ADDENDUM NUMBER ONE

Bids Received until
2:00 P.M. CDT November 17, 2011
Hoover City Schools Board of Education
2810 Metropolitan Way
Hoover, Alabama 35243

Harold L. Foshee Architects
345 Highgate Hill
Indian Springs,
Alabama 35124

**ADDITIONS TO
HOOVER HIGH SCHOOL
HOOVER, ALABAMA**

DRAWING NO.: SD-E6

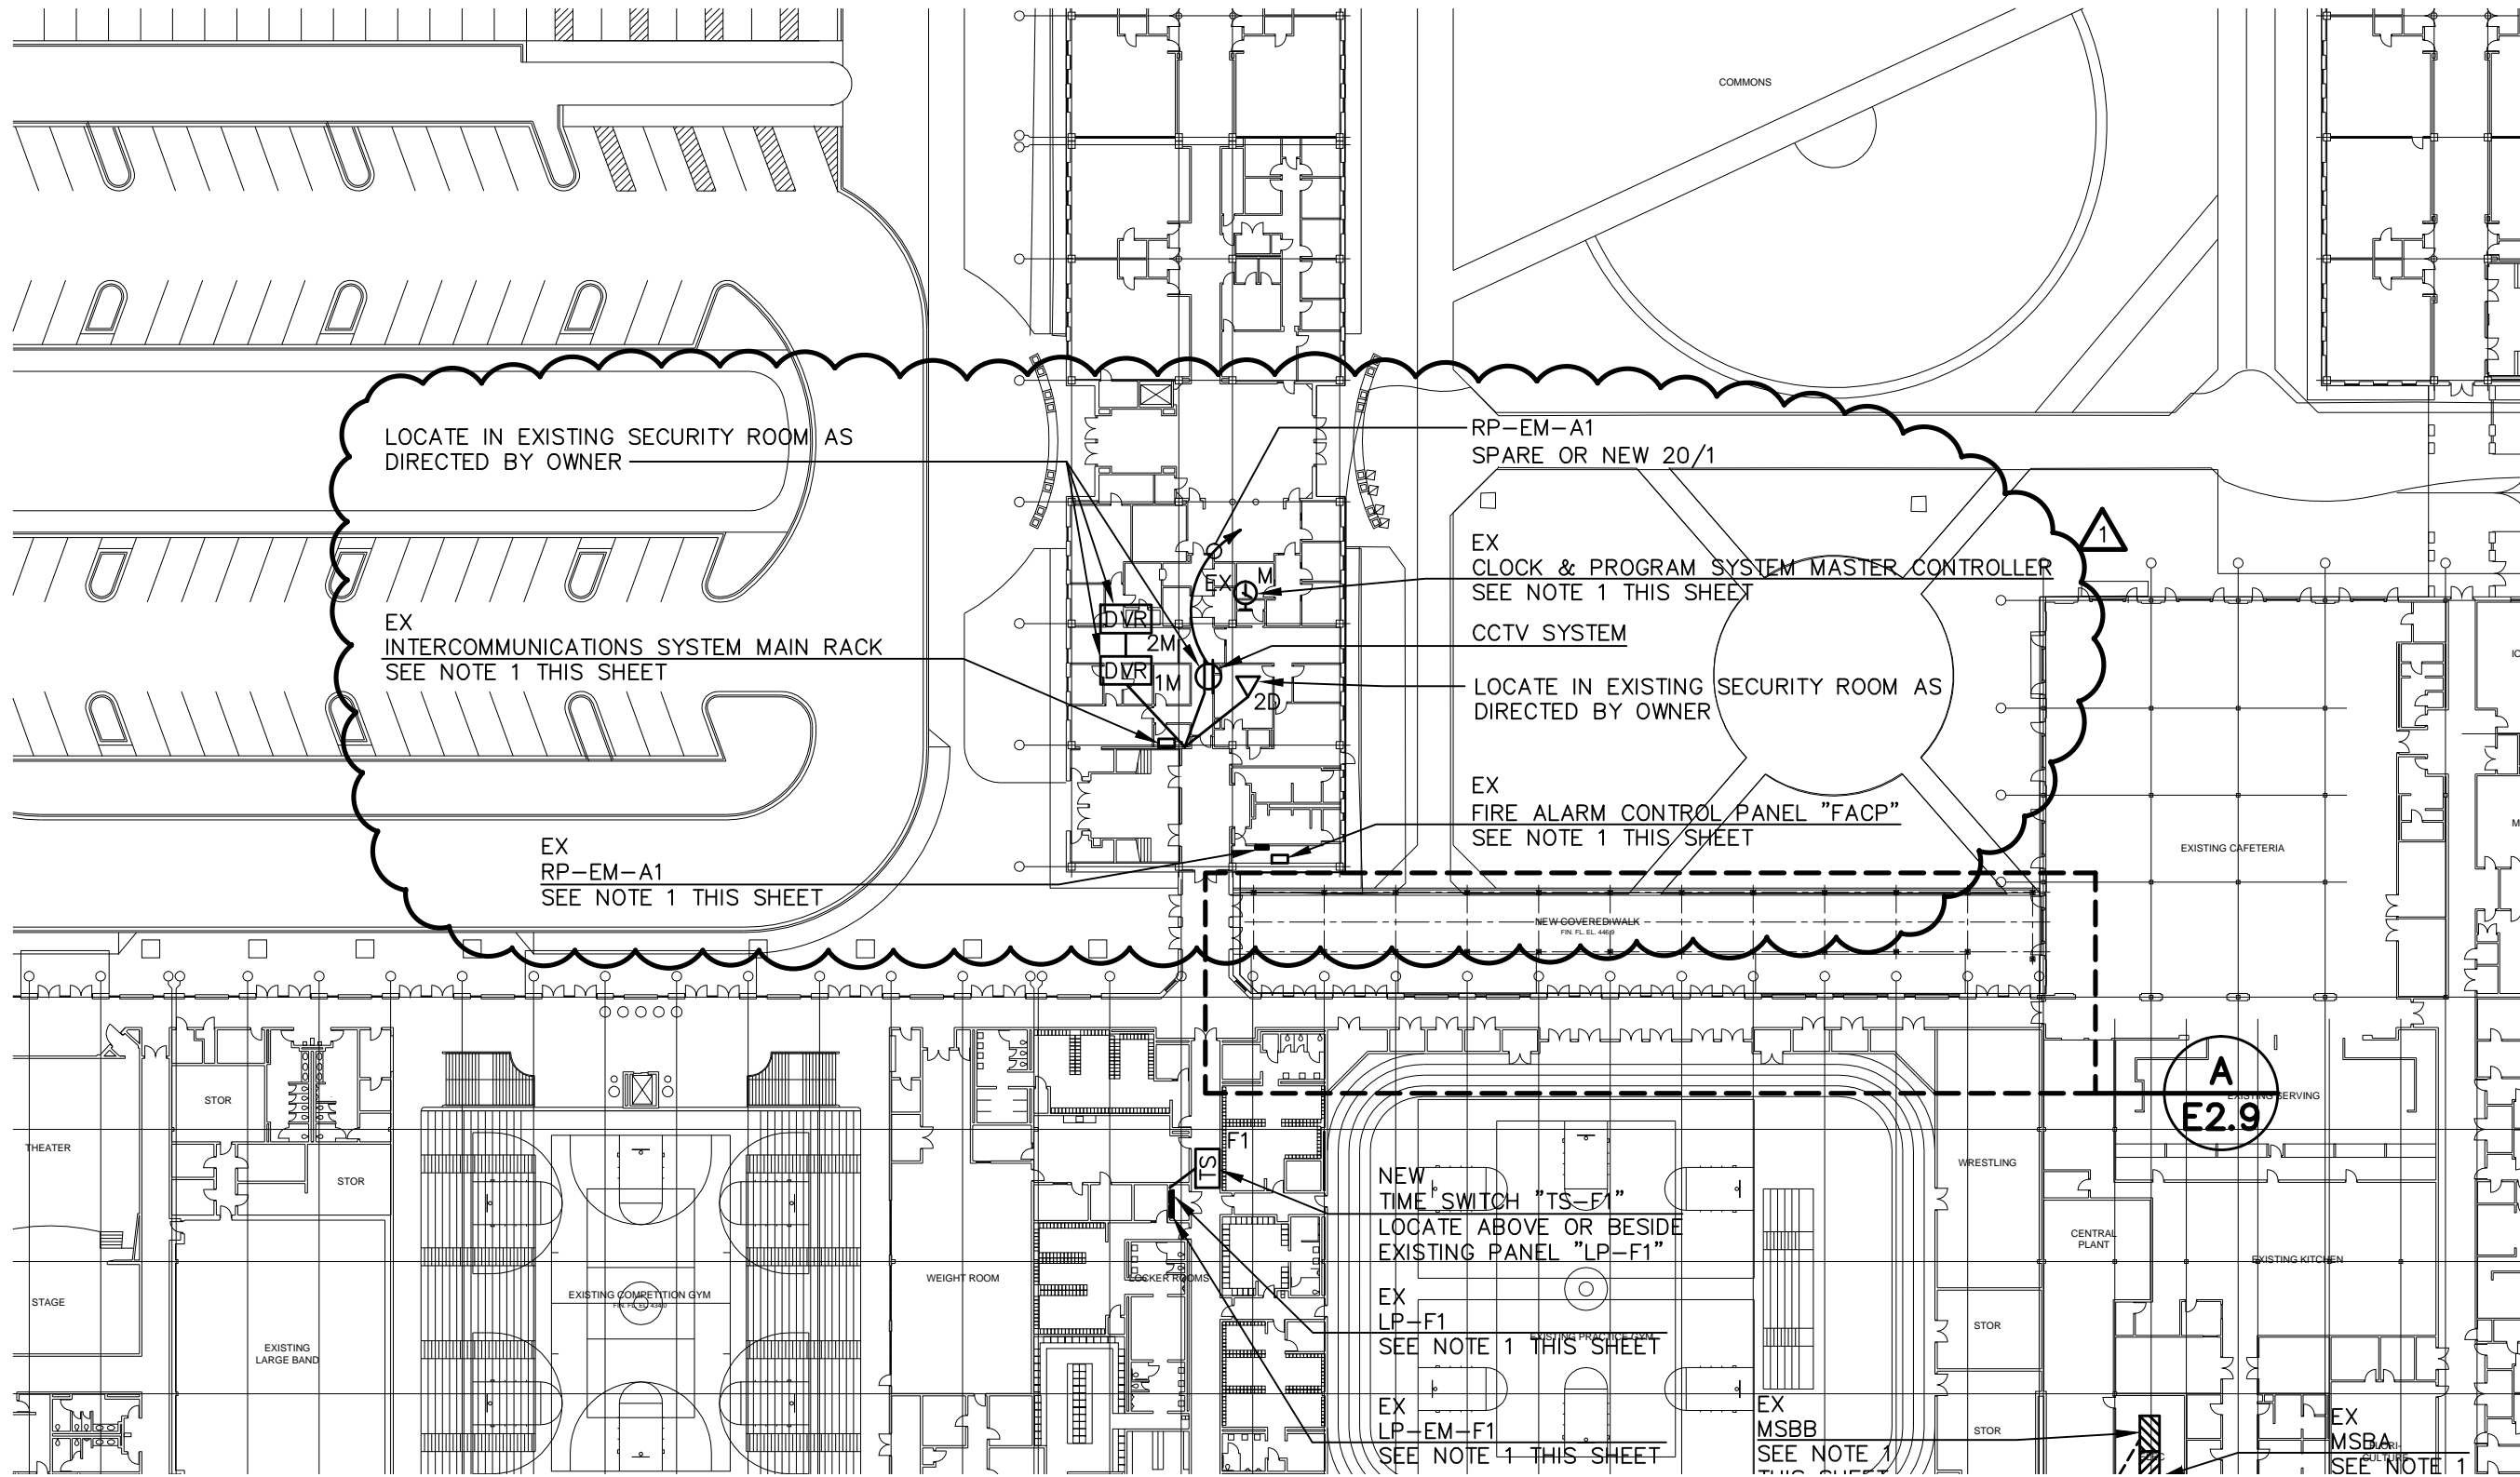
D1.27 Sheet No. E3.3:

A. Revise as shown on attachment SD-E6.

DRAWING NO.: SD-E7

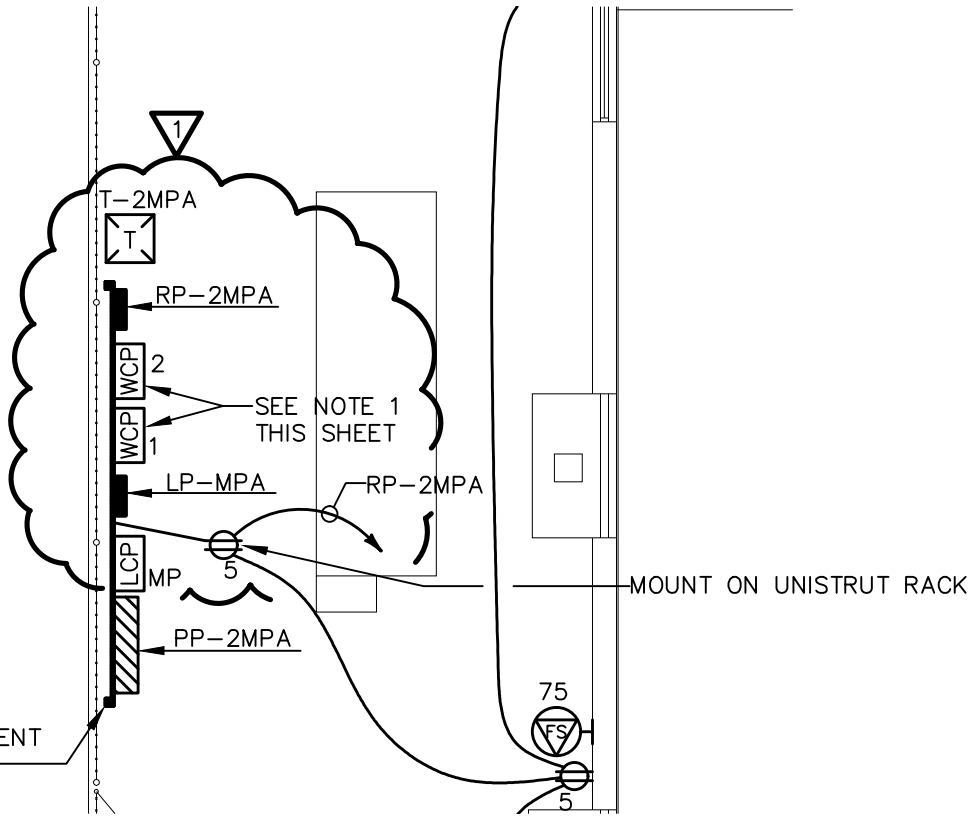
D1.21 Sheet No. E0.1:

A. Revise Electrical Site Plan as shown on attachment SD-E7.

PROJECT: ADDITIONS TO HOOVER HIGH SCHOOL			
SHEET TITLE: MULTI-PURPOSE SECOND FLOOR POWER & AUXILIARY PLAN			
REF. SHEET: E3.7	JRA JOB NO.: 211093	DATE: 11/08/11	DRAWING NO.: SD-E8

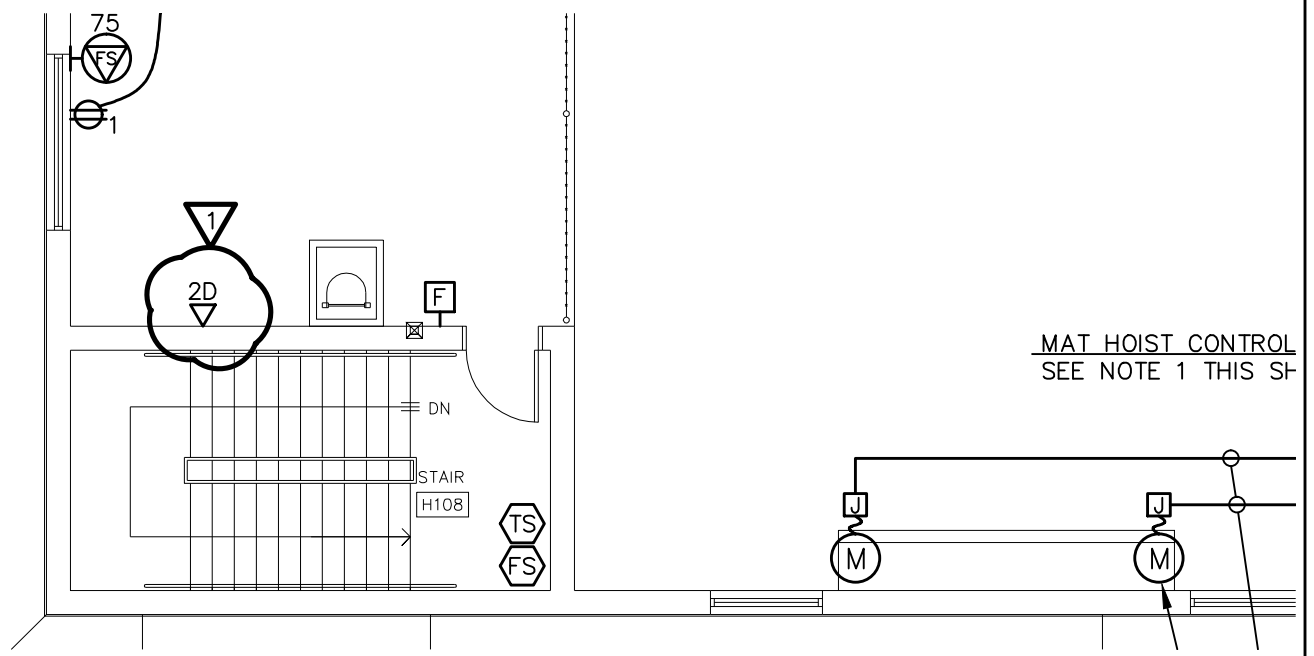
D1.29 Sheet No. E3.7:

A. Revise as shown on attachment SD-E8.

NEW TIME SWITCH "TS-F1"
 LOCATE ABOVE OR BESIDE
 EXISTING PANEL "LP-F1"
 EX LP-F1
 SEE NOTE 1 THIS SHEET
 EX LP-EM-F1
 SEE NOTE 1 THIS SHEET

REF. SHEET: E4.7 JRA JOB NO.: 211093 DATE: 11/08/11 DRAWING NO.: SD-E9

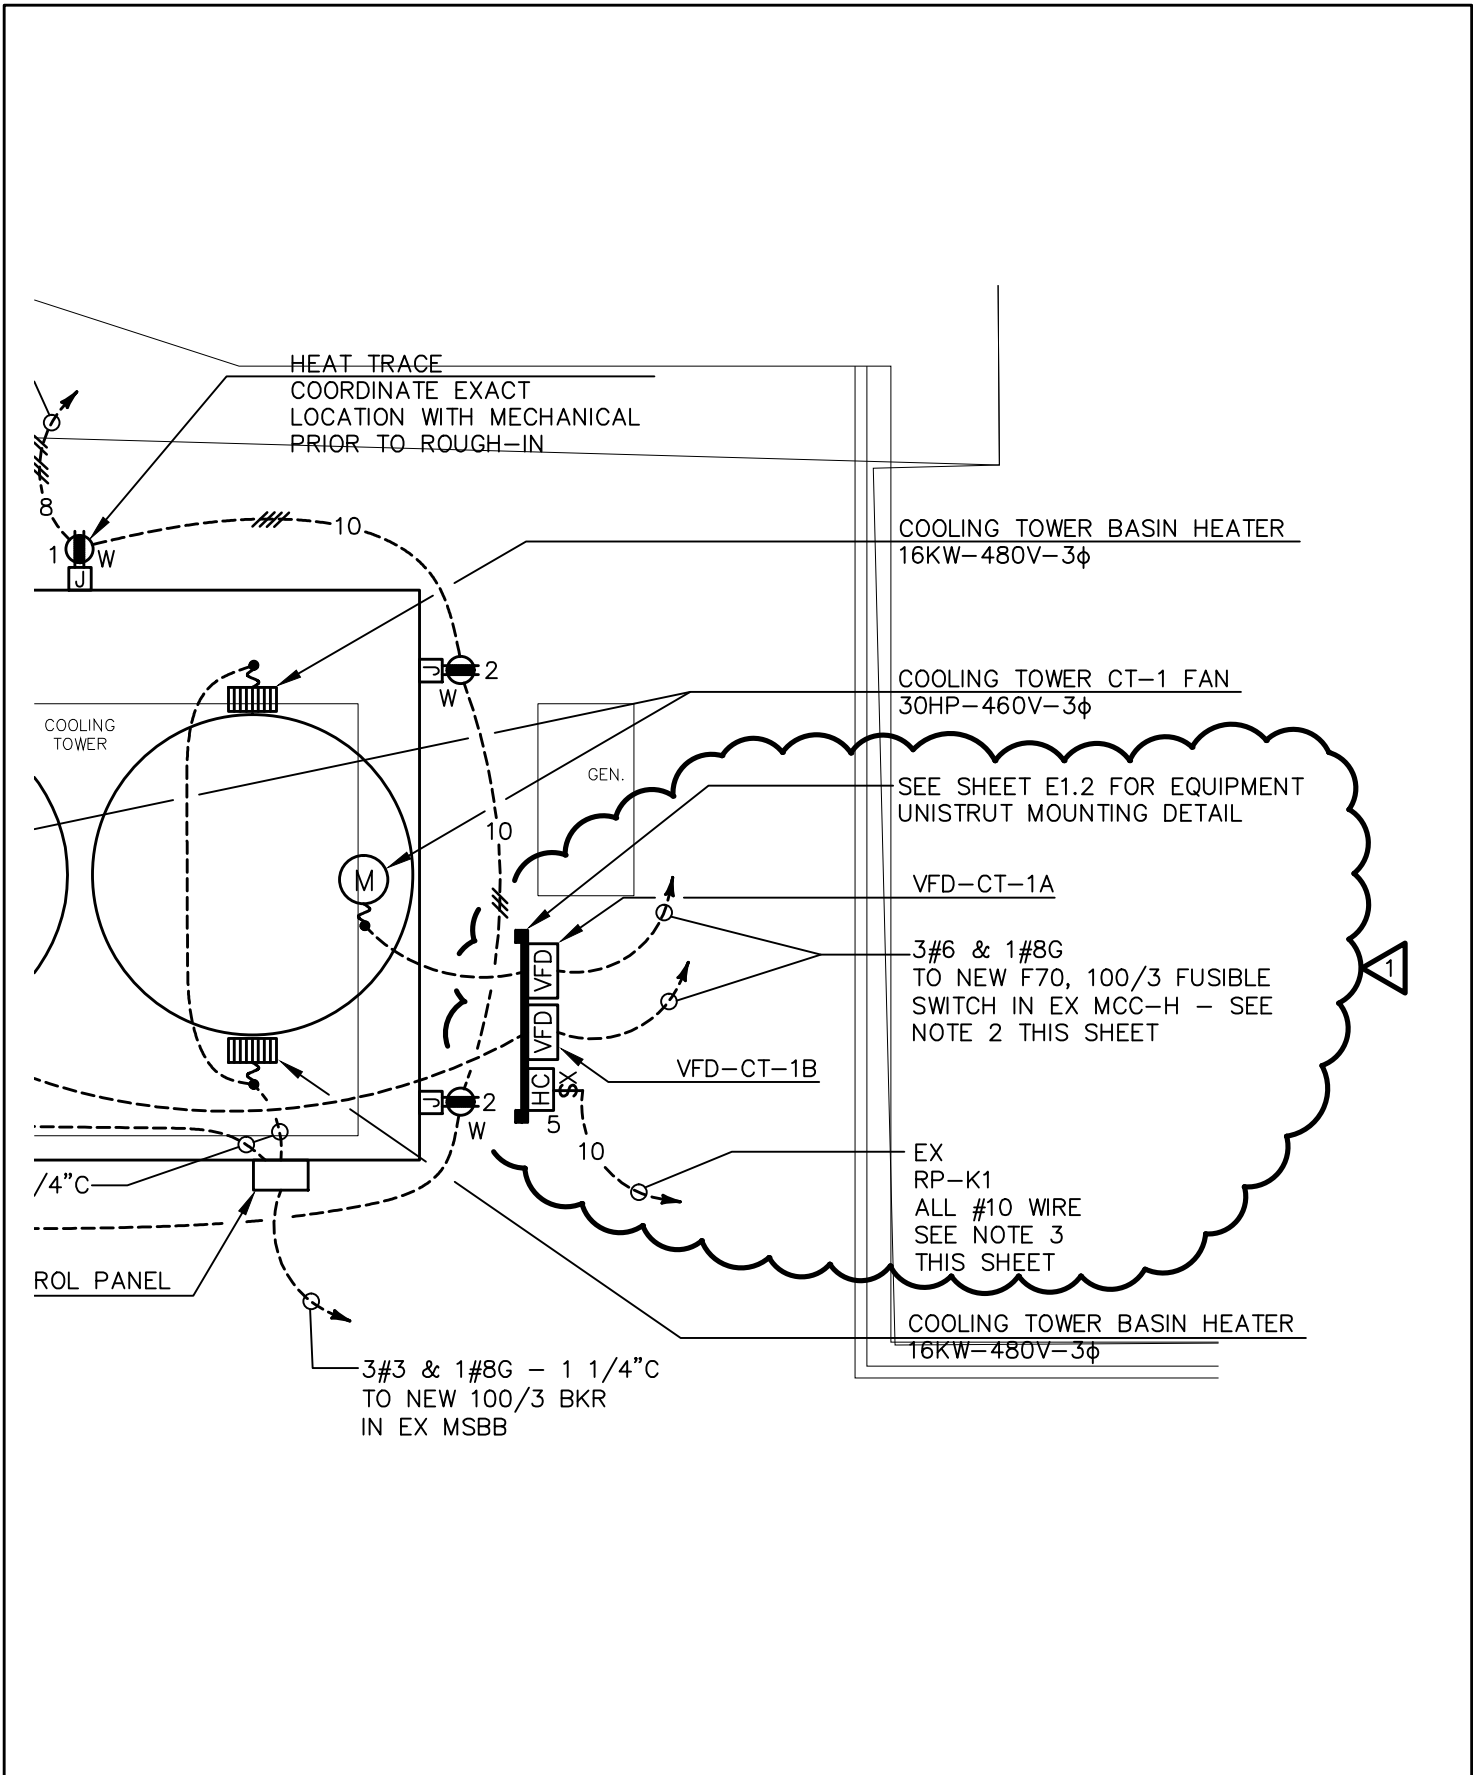
D1.32 Sheet No. E4.7:

A. Revise as shown on attachment SD-E9.

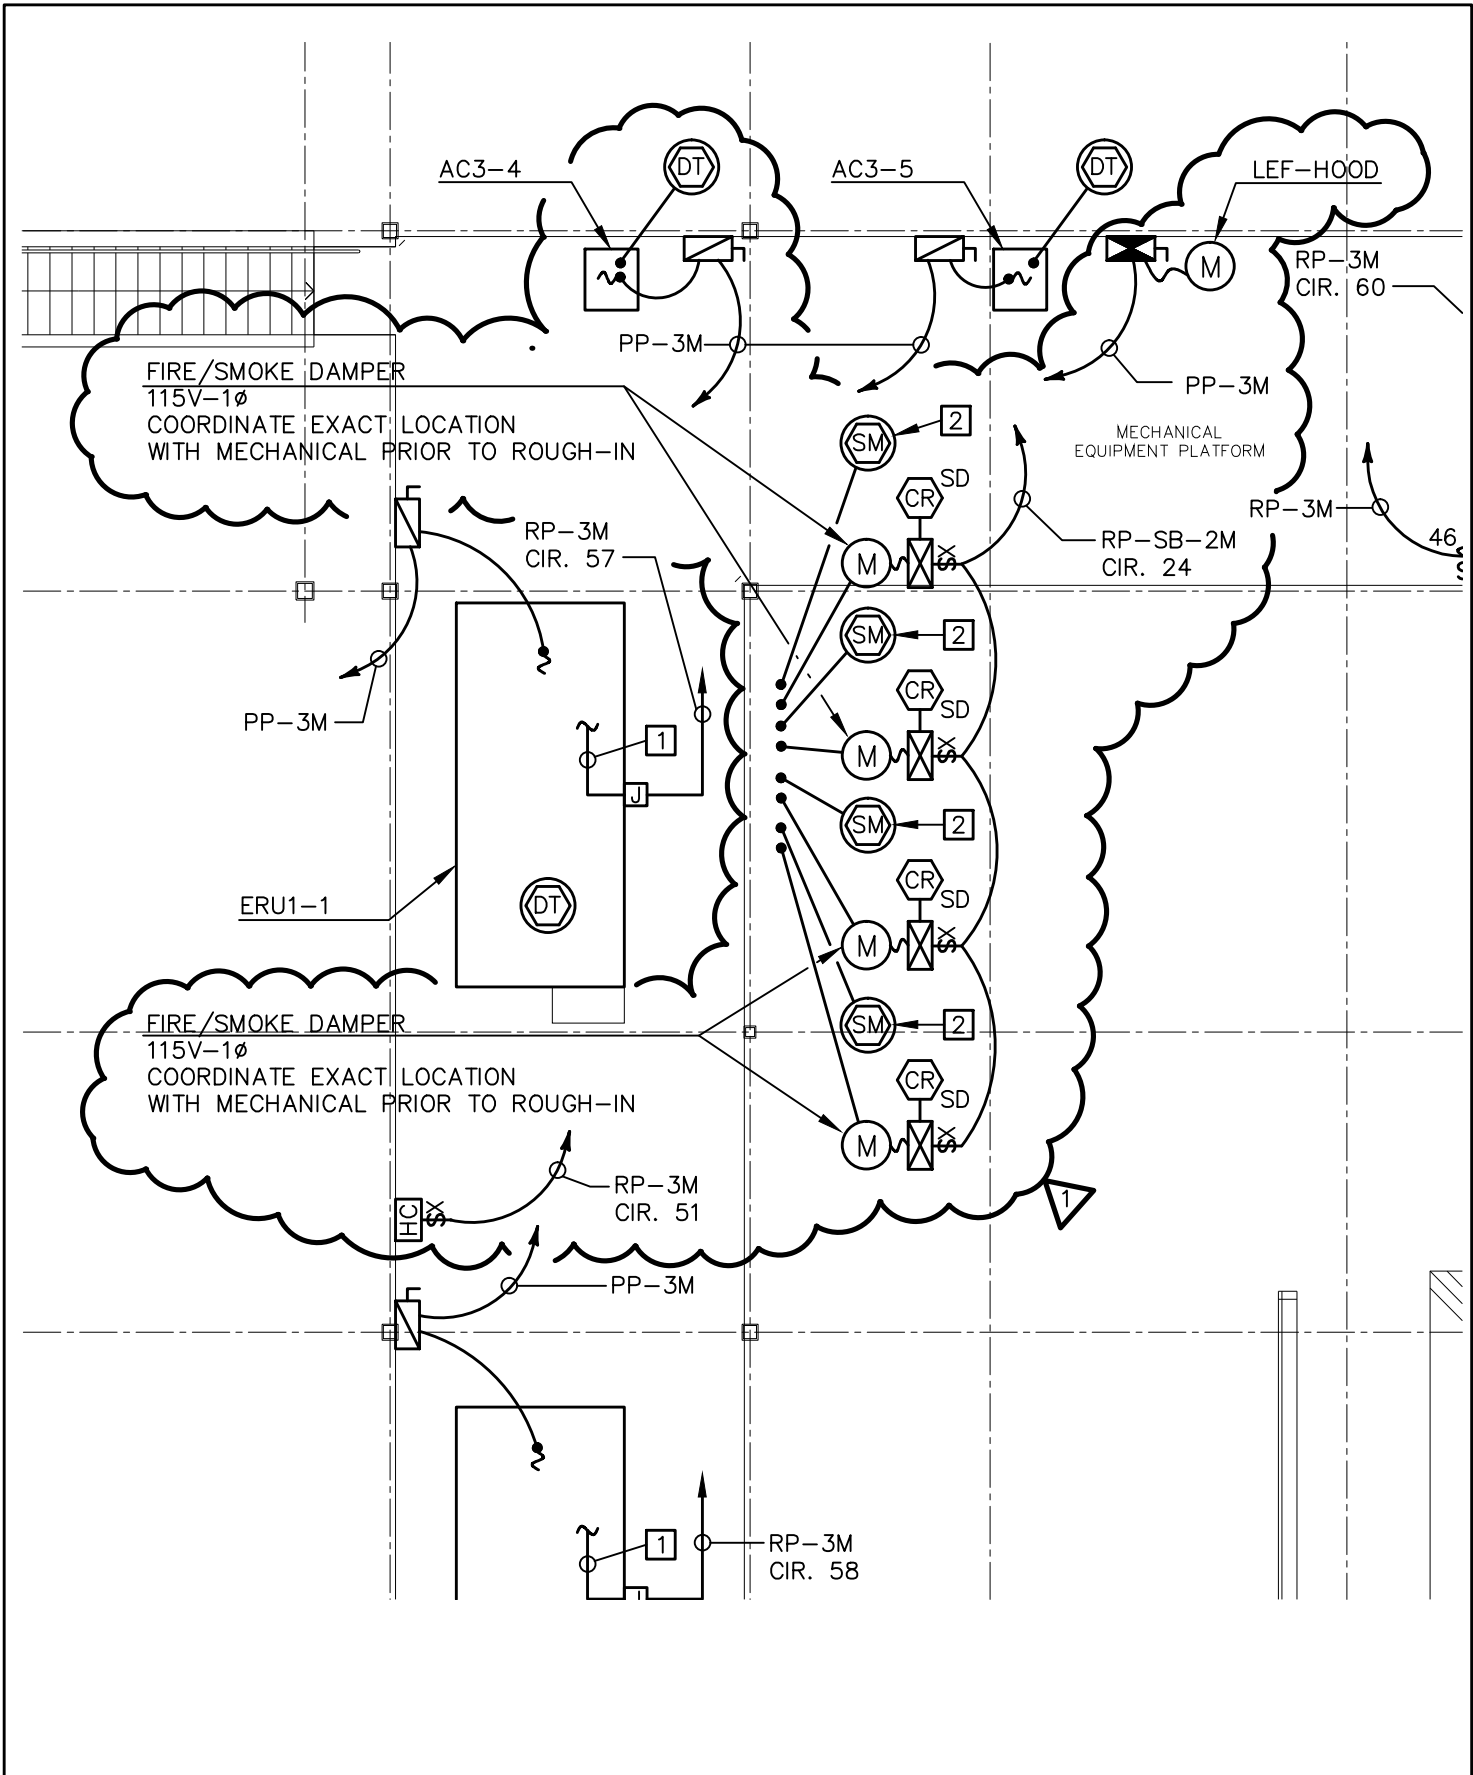
D1.22 Sheet No. E0.2:

A. Revise Central Plant Electrical Plans as shown on attachment SD-E7.
